Re: Comments on "Feasibility Study" and "Proposed Plan for
Remediation", Tutu Well Site, St. Thomas,
Virgin Islands

COMMENTS ON FEASIBILITY STUDY AND PROPOSED PLAN FOR REMEDIATION
TUTU WELL SITE, ST. THOMAS, UNITED STATES VIRGIN ISLANDS
SUBMITTED ON BEHALF OF L'HENRI, INC.

Comments
Final Remedial Investigation (RI) Report
Tutu Wells Site, Tutu, St. Thomas
Report Prepared by Geraghty and Miller (April 1995)
Comments by IT Corporation for L'Henri Inc. (June 7 1995).

Figure S-30

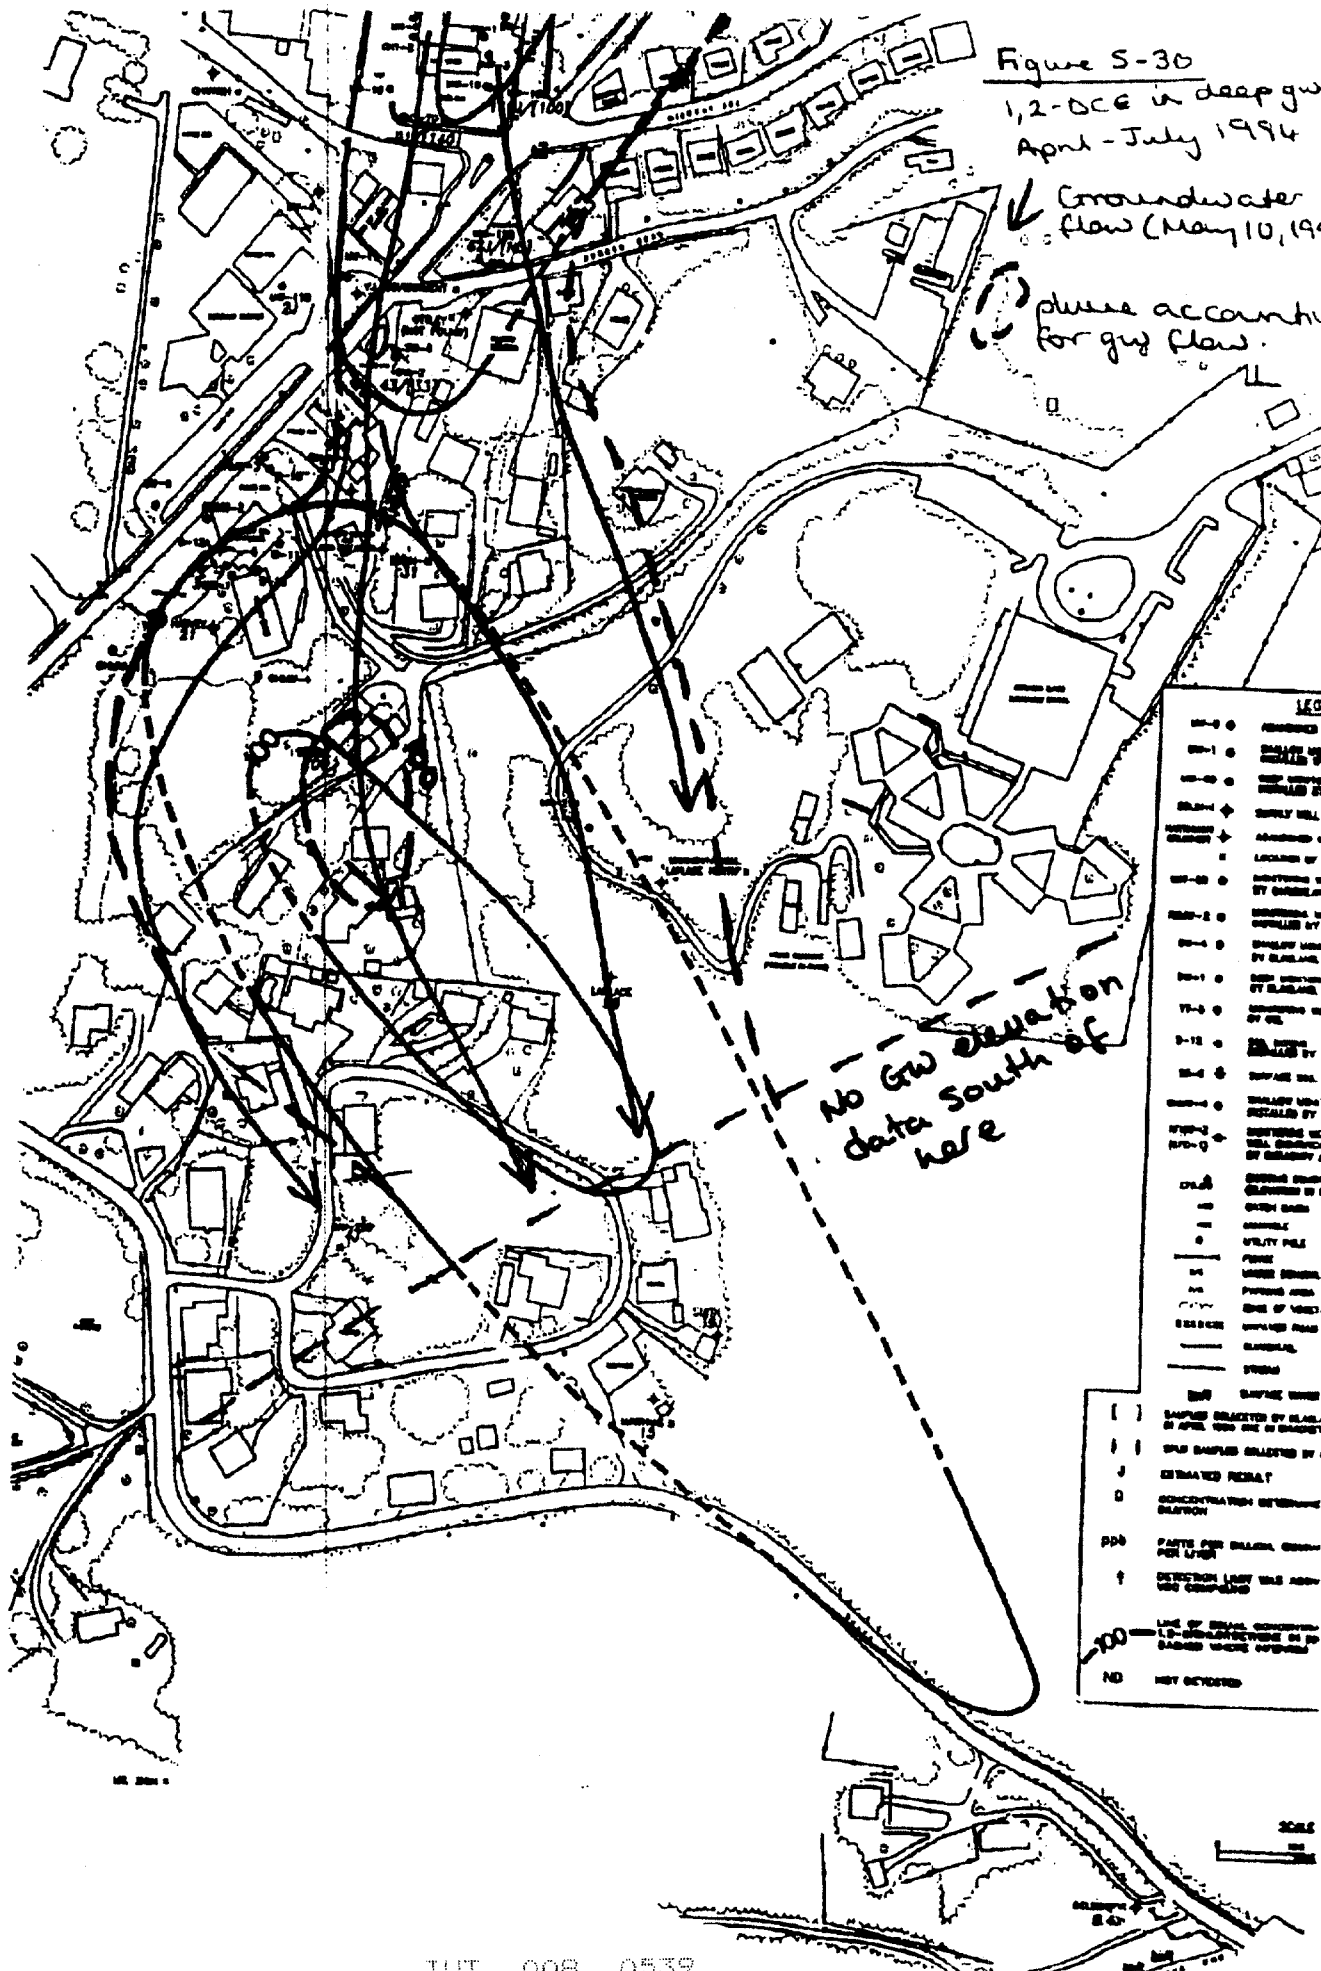
please account
for gw flow.

No GW elevation
data south of
here

Figure 4-12

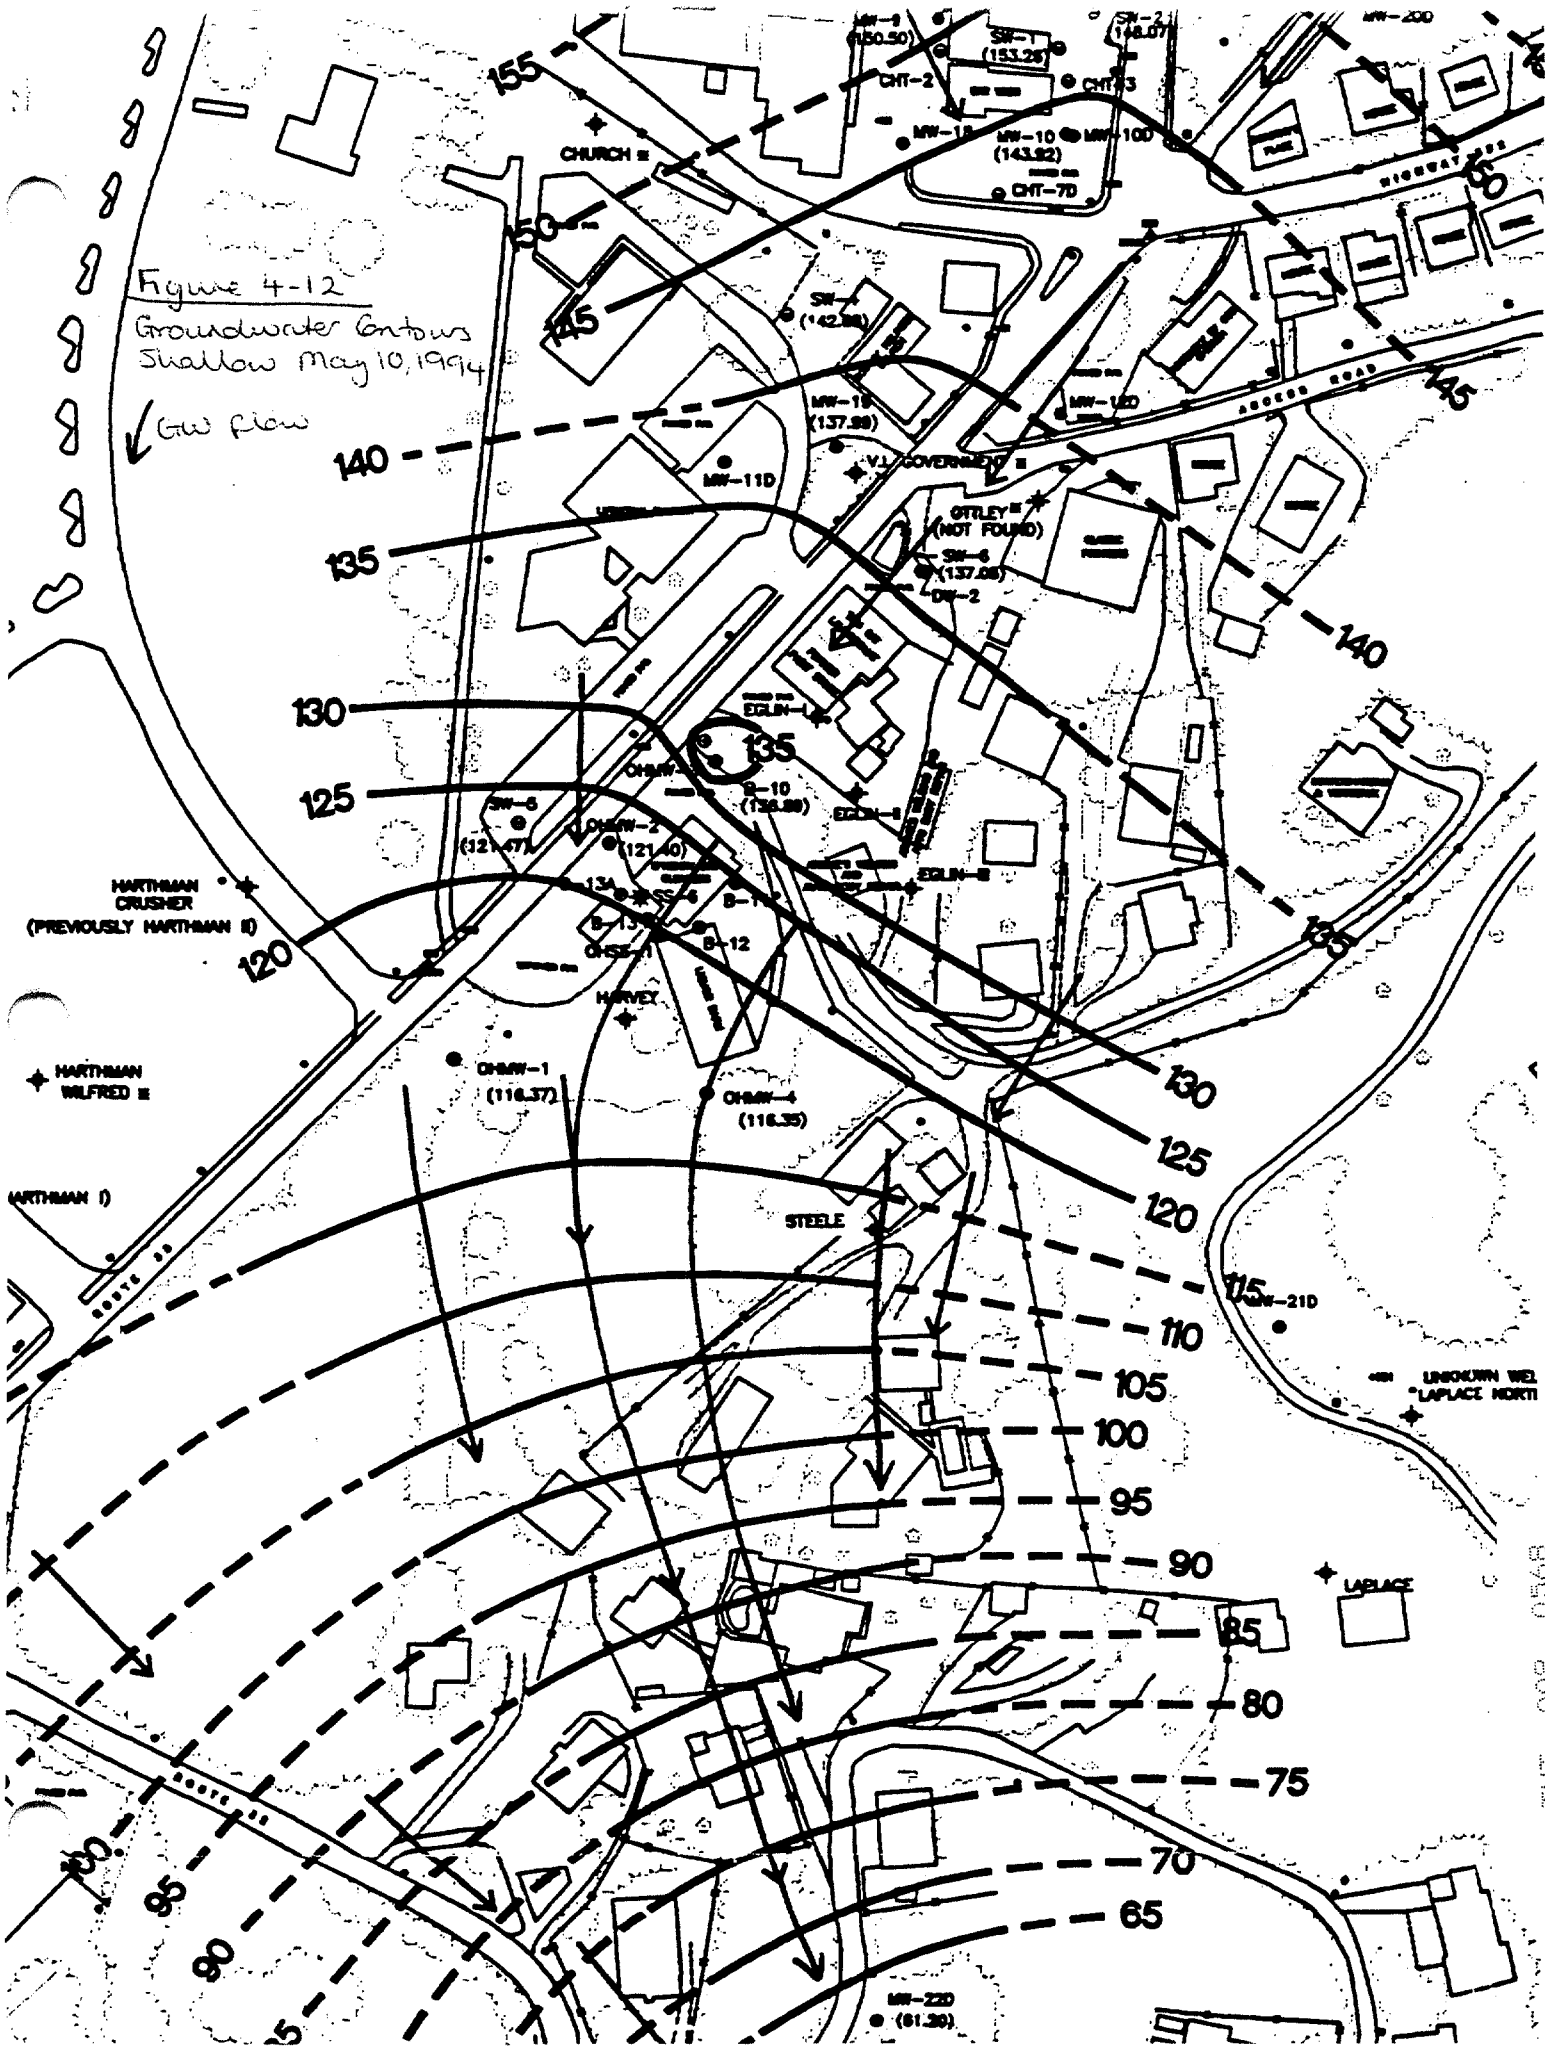
GW flow

Figure 4-14

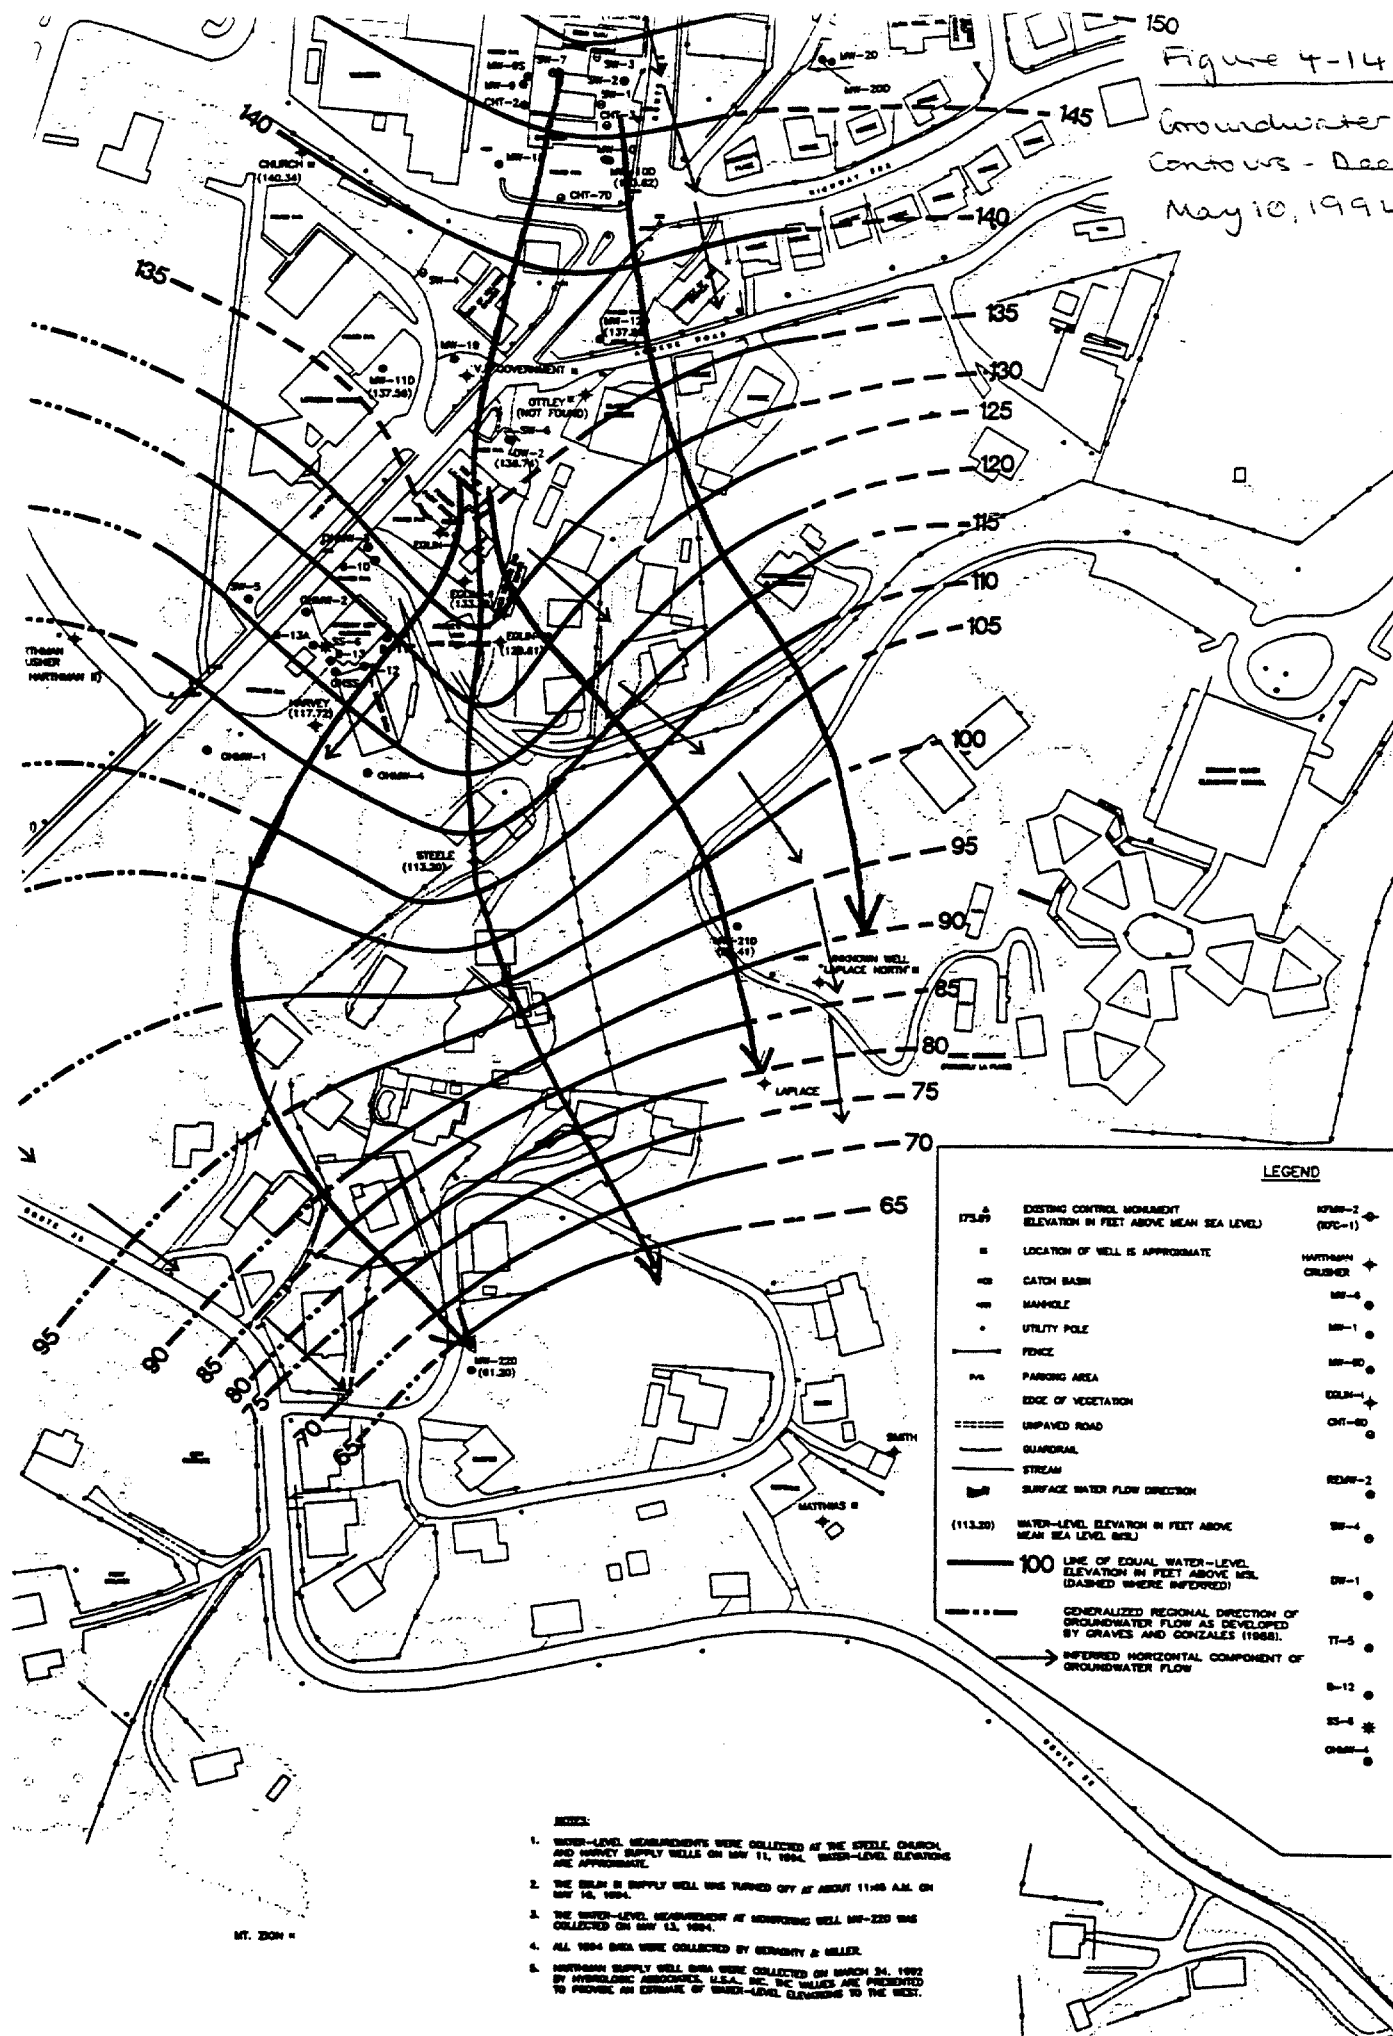
The presentation of PCE, TCE and 1,2-DCE in deep groundwater (figures 5-26, 5-28 and 5-30 respectively) are not consistent with the appropriate deep groundwater flow map (see

comment 1 above) for the deep groundwater (figure 4-14) as presented in the RI (figure 4-14). To develop more defensible plume maps for these compounds, flow lines were drawn on figure 4-14 (attached). Then flow lines were transferred to the plume maps and the plumes redrawn to take into account the flow directions (attached). The redrawn plume maps (which include a 5 ppb line for TCE) indicate similar patterns for the PCE, TCE and 1,2-DCE plumes, showing a wider plume in the area extending from the Eglin well to the LaPlace well as reflective of the divergent groundwater flow. Further it should be noted that no groundwater elevation data is available south of MW-22D therefore the plume is conjectural downgradient of that location.
